SUBJECT: SECOND REQUEST FOR ADDITIONAL INFORMATION REGARDING THE  
TRANSNUCLEAR NUHOMS® HD HORIZONTAL MODULAR STORAGE  
SYSTEM (TAC NO. L23738)

Docket No.: 72-1030  
TAC No. L23738

**REQUEST FOR ADDITIONAL INFORMATION  
TRANSNUCLEAR, INC.  
DOCKET NO. 72-1030**

**Figure 2**  
Maximum displacement of Top rod limited by Rod-to-rod Contact and Assembly/Basket Gaps During Side Drop

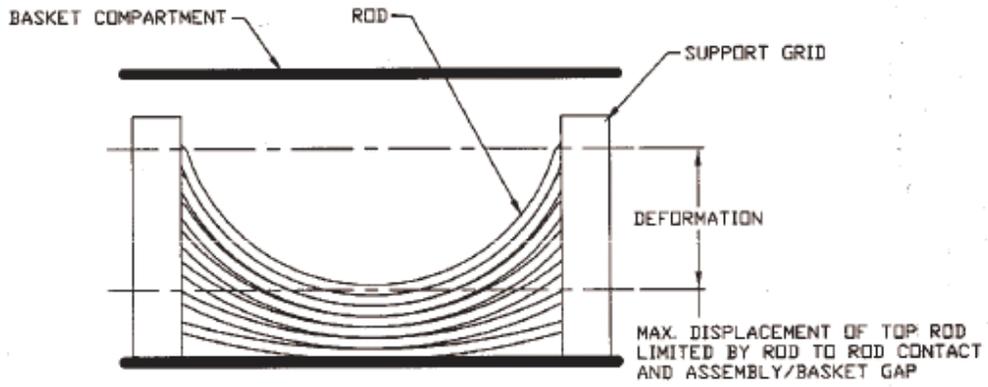
First round RAI 3-13 requested justification for the fuel rod moment of inertia (MI) used in performing the side drop fuel rod structural integrity evaluation in Appendix 3.9.8, Section 3.9.8.11.1. Therein TN used a MI equal to  $\frac{1}{2}$  the MI of the cladding plus  $\frac{1}{2}$  the MI of the fuel. TN's response justified this approach by assuming composite behavior between the fuel and cladding based on physical conditions that exist during in-reactor operations that result in compressive radial stresses between the fuel and cladding. The staff found these in-reactor conditions to not be applicable to spent fuel in storage due to the significant difference in the pressure and temperature environments between in-reactor operation and storage conditions. (Essentially, in storage the fuel is in a highly fractured condition with little or no radial compression forces acting on the fuel.) It is also noted that in this first round response the applicant did not mention nor address the fact that for the drop analysis performed in Section 3.5.3.1 Table 3-12 the full MI of both the cladding and fuel was used.

After discussions with TN, the staff received a second analysis in an email dated March 25, 2005, (this second analysis is documented below) that did not rely on composite behavior between the fuel and cladding, and addressed both Appendix 3.9.8, Section 3.9.8.11.1 and Section 3.5.3.1. Part A of the second analysis addressed Appendix 3.9.8 - a one foot side drop load of 30g. This analysis treated the fuel rod as a continuous beam over multiple supports and considered the bending resistance (MI) of only the cladding. The staff found this approach acceptable. Part B of the second analysis addressed Section 3.5.3.1 Table 3-12 - a side drop load of 75g. For this analysis TN abandoned the approach used in Part A and instead pursued a displacement limited approach. TN assumed the fuel rod was not a continuous beam over multiple supports (the model that had been used in Part A), but rather assumed that it was a simply supported beam spanning between adjacent grid spacers - the most flexible condition possible - and imposed a displacement limit approximately equal to the maximum total gap between adjacent fuel rods plus the gap between the assembly and basket. Because of the simply supported beam assumption, the staff found the approach in Part B to be non conservative and inconsistent with actual fuel rod behavior during a side drop event and, therefore, unacceptable.

The lateral restraint, shown in Figure 2, is based on all fuel rods having the same deformation pattern, with their lateral deformation constrained by the assembly and basket. This deformation is the maximum deformation possible regardless the applied g load. This assumption is justified since the basket structural stiffness is very large relative to the structural stiffness of the fuel assemblies and

The rod stress evaluation presented in the previous Section (A) due to 30g side drop is based on methodology described on LLNL report (Reference 1) and is based on modeling the fuel rod as a simply supported beam. In this methodology, the deflection of the rod is a function of the applied g-load and spacer grid span. In reality, as described in SANDIA report (Reference 2), as the g load increases due to the accident drop load, the deformation of the fuel rod is limited by the continuous support provided by the basket fuel compartments. The fuel compartment tube structure provides a rigid support structure to the fuel assembly. Figure III-6 from the referenced SANDIA report (reproduced here as Figure 1) shows that the maximum displacement of the center rod is limited by rod-to-rod contact and assembly/basket gaps during the accident end drop load. A similar situation can occur during the side drop accident load. Figure 2 illustrates the process by which the lateral deformation is limited to the sum of the gaps between individual rods in the assembly plus the thickness of the support grid.

Following is the example of this methodology based on the geometry of WE15x15:

$$\delta = [(rod\ pitch - rod\ OD) - (no.\ of\ rods\ in\ a\ row - 1)] + \{assembly\ width - [rod\ pitch \times (no.\ of\ rods\ in\ a\ row - 1)] - rod\ OD\} / 2$$

$$\begin{aligned}\delta &= [(0.563'' - 0.4193'') - (15-1)] + \{8.426'' - [0.563'' \times (15-1)] - 0.4193\} / 2 \\ &= 2.0118'' + 0.06235'' \\ &= 2.07415''\end{aligned}$$
